RE: **Lot 35 Block 6 Unit 2 SAD 227**
7904 Kibo Rd. NW
Unser Cliffs Subdivision
Grading and Drainage Plan
Engineers Stamp Date 1/25/19 (E10D056)

DRAINAGE AND TRANSPORTATION INFORMATION SHEET (REV 6/2018)

RE: **Lot 35 Block 6 Unit 2 SAD 227**
7904 Kibo NW
Volcano Cliffs Subdivision
Grading and Drainage Plan
Engineers Stamp Date 1/22/19 (E10D056)

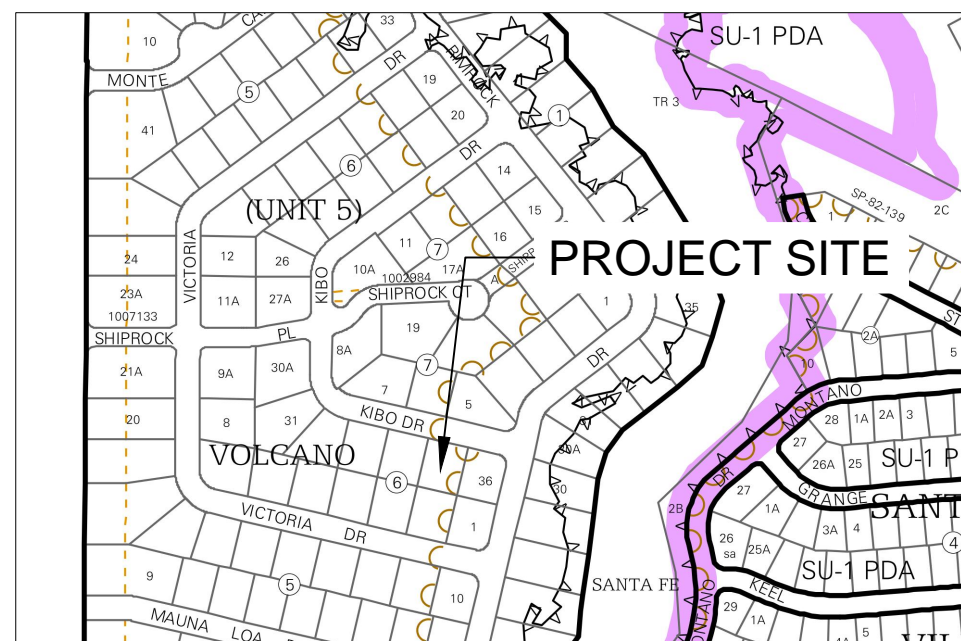
- Provide a section of the NE corner showing how the flows will drain to Kibo Ave. or a pond which will hold the 100 year 10 day volume.
- Provide the easement on the west side of the property.

1. Ponding was increased to provide capacity for the 100yr, 10 day event.
2. The easement on the west side of the site, along with the 5' and 7' utility easements on the east and south have been included.
